RX-8

New Front Cover Design RI5698

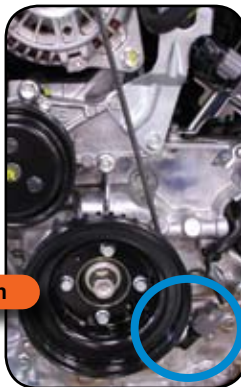
When installing an engine into an RX-8, you may notice the mount for the eccentric shaft position sensor on the front cover is shaped differently. This new design is compatible with all current eccentric shaft position sensors installed on all 2004-2008 RX-8 vehicles. Also, 2006-2008 RX-8 vehicles produced from 4/1/2006 use this new front cover design. DO NOT replace the front cover.
